SUPPLEMENTARY SHEET

For the RC10DS Qualifier kit

These are actual size drawings of the new parts:

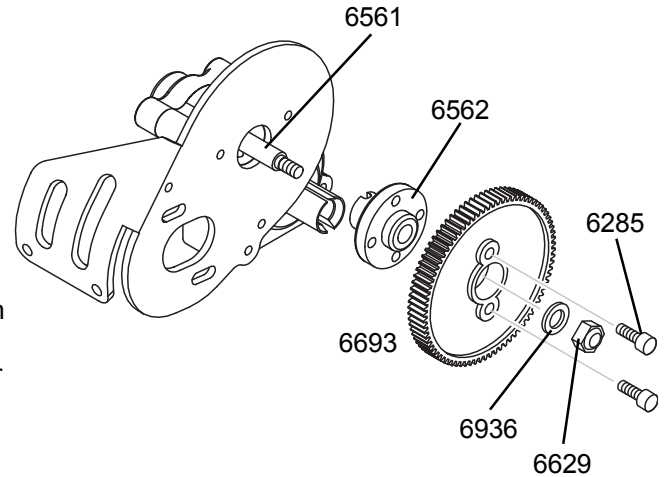
Page 21, Fig. 63, Figs. 64 & 65 We have replaced the entire Associated Torque clutch assembly with the new, inexpensive, **#6562 spur gear adapter**. You will not be using parts #6583, 6584, 6585, 6596, 6594.

Replace the text for Figs. 63-65 with the following text. Slide on the #6562 adapter as shown in the drawing at right so that it fits neatly over the roll pin of the #6561 drive gear shaft. Secure the new spur gear adapter with one #6936 #4 aluminum flat washer and one #6629 5-40 locknut (gold colored) as shown.
